ARKANSAS
Department of Environmental Quality

INTEROFFICE MEMORANDUM

RE: Site visit at Cooper Tire, Permit No. AR0038822

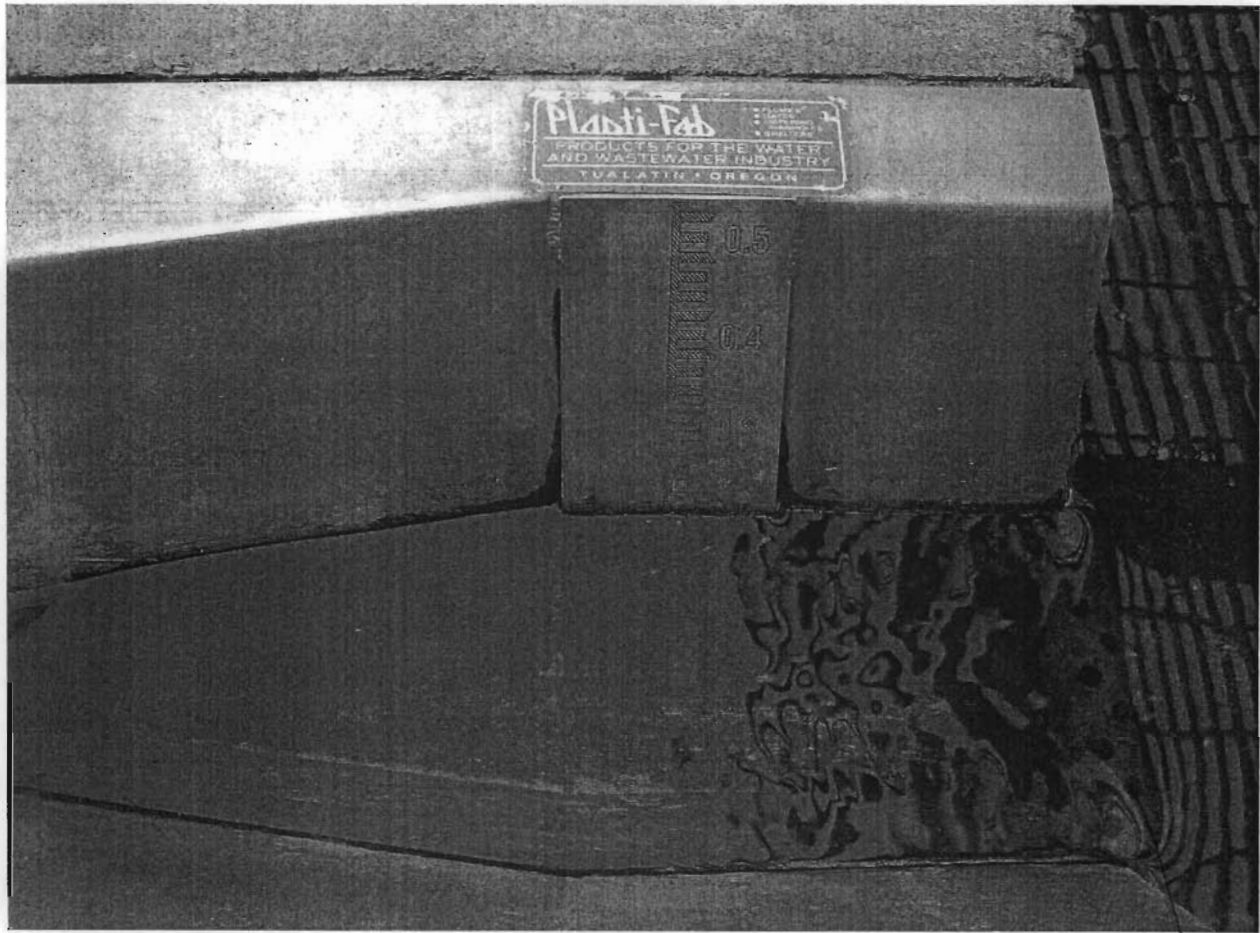
Close up view of V-notch weir. At time of site visit the flow rate indicated by this weir was 12 gpm (0.01728 mgd). The maximum flow this weir can measure is 122.4 gpm (0.17632 mgd). At the inlet of the weir you can see the automated sample collection probe with perforated holes. This is the sample location for all parameters required by the permit.

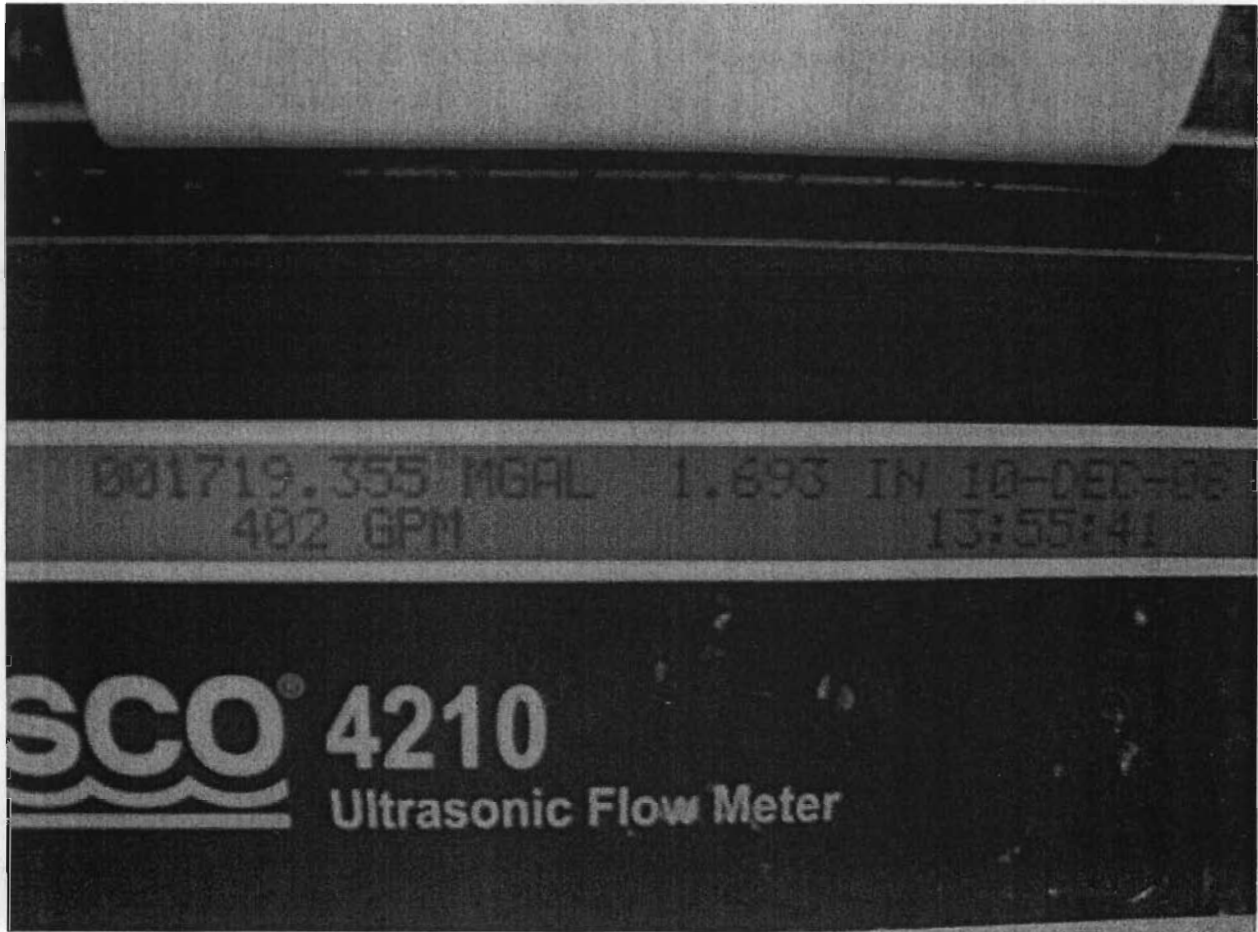
This is the totalizer meter. At the time of visit, it was recording a flow rate of 402 gpm. However, the V-notch weir indicated an actual flow of 12 gpm.

The flow rate being reported by the totalizer meter seems to be in error. This issue was discussed with Charles Allen at the time of the site visit. Mr. Allen stated that he attempts to make corrections for this difference when determining the flow number that is reported on the DMR. However, I suggested to him that he should look into removing the V-notch weir and relocating it on the upstream end of the open channel, and moving the transducer location to the downstream end of the channel. The total length of the open channel is approximately 60 feet, therefore moving the V-notch weir to the upstream end would still allow accurate low flow measurements and would remove the downstream obstruction currently caused by the weir being installed downstream of the transducer. He stated that they had talked about that solution before, but nothing had been done yet.
